UNITED STATES PATENT AND TRADEMARK OFFICE

10/711,326

Office Action Summary	Application No. 10/711,326	Applicant(s) NAKANO ET AL.	
	Examiner THOMAS W. IRVIN	Art Unit 3683

DETAILED ACTION

Figs. 1 and 2 (US Patent 3,168,836)

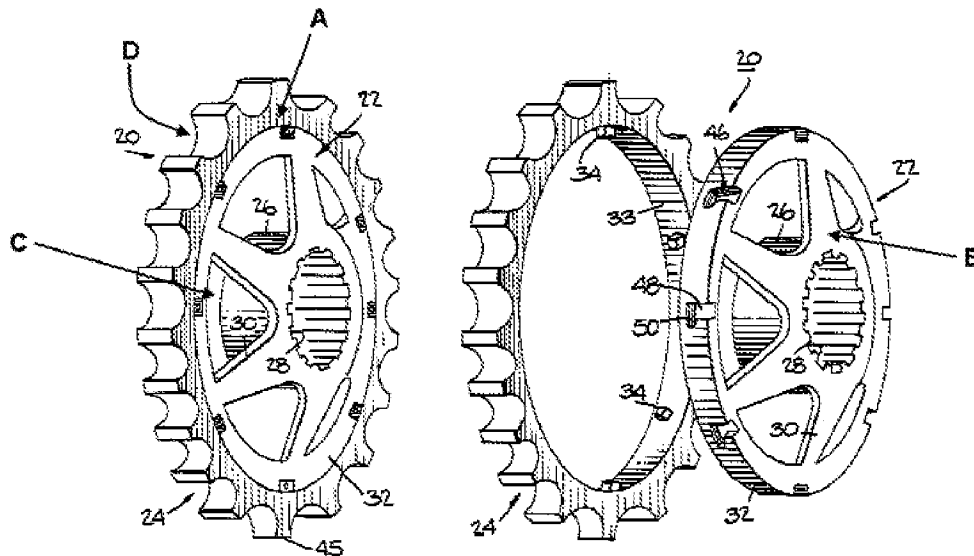
In Re claim 1, with reference to Figs. 1 and 2 shown above, '836 discloses a bicycle sprocket, wherein the sprocket comprises: a sprocket body (20); a plurality of teeth (45) extending radially outwardly from the sprocket body; a spline (28) extending radially inwardly from the sprocket body; wherein the spline includes a radially outer surface (26) facing radially outwardly; and wherein the radially outer surface of the spline faces a radially inner surface (33) of the sprocket body.

In Re claim 3, the inner surface is substantially straight in a direction of the rotational axis.

In Re claim 4, the inner surface is substantially parallel to the rotational axis.

In Re claim 5, the sprocket body has a side wall that includes a first side wall portion (A) and a second side wall portion (B), wherein the plurality of teeth extend radially outwardly from the first side wall portion, and wherein the second side wall portion is laterally offset from the first side wall portion.

In Re claim 6, the second side wall portion overlaps the outer surface (26) when viewed in a direction parallel to the rotational axis.

In Re claim 7, the second side wall portion is spaced apart from the first side wall portion in a direction of the rotational axis.

In Re claim 8, the spline is offset from the first side wall portion in a direction of the rotational axis.

In Re claim 9, the spline extends from the second side wall portion and terminates at a free end (C), and the free end is spaced apart from a first side wall (D) of the first side wall portion (A) that faces in a same direction as the free end.

In Re claim 10, the sprocket body has a side wall that includes a first side wall portion (A) and a second side wall portion (B), wherein the plurality of teeth extend radially outwardly from the first side wall portion. It is the examiner's understanding that the second side wall portion and the spline together form a composite spline.

In Re claim 11, a thickness of the spline in a direction of the rotational axis is greater than a thickness of the second side wall portion in a direction of the rotational axis.

In Re claim 13, with reference to Figs. 1 and 2 shown above, '836 discloses a bicycle sprocket, wherein the sprocket comprises: a sprocket body (20); a plurality of teeth (45) extending radially outwardly from the sprocket body; a spline (28) extending radially inwardly from the sprocket body, wherein the spline has a root portion (30) and a radially inner portion (26), wherein the root portion extends radially inwardly of the sprocket body and has a side wall (B) facing in a rotational direction, and wherein the

radially inner portion extends radially inwardly of the root portion and has a side wall (C) facing in the rotational direction; and wherein a thickness of the radially inner portion of the spline in a direction parallel to the rotational axis is greater than a thickness of the root portion of the spline in a direction of the rotational axis.
